LEGISLATIVE HALL
Roof Repairs and Replacement
411 Legislative Avenue
Dover, Delaware

ADDENDUM #2
July 18, 2013

OMB/DFM Contract No. MC1002000188

1 ALTERNATE No.3
 MECHANICAL WELL PANEL BASE DETAIL
 SK-1 SCALE: 3"=1'-0"

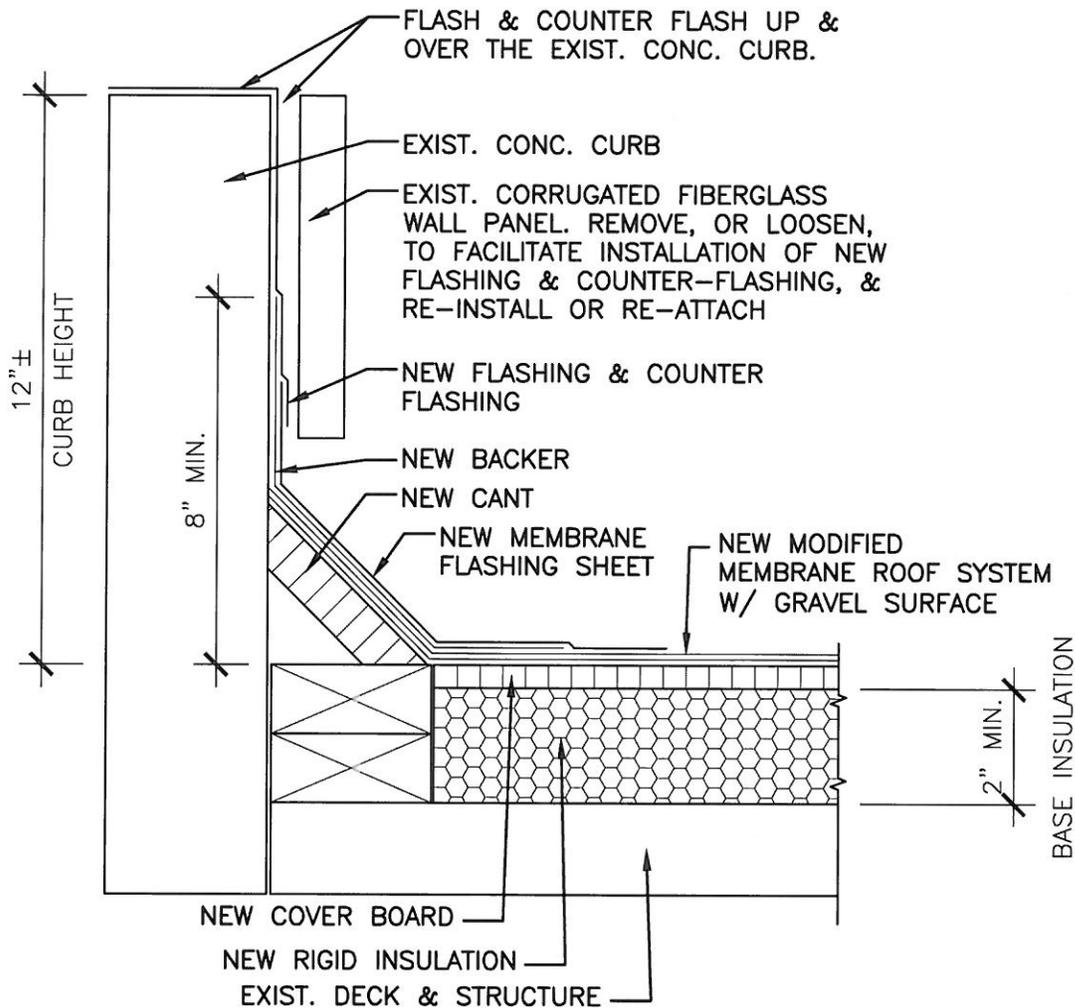
Delete detail 8/A103. See revised detail 1/SK-1 on sketch drawing No. SK-1 included in this addendum.
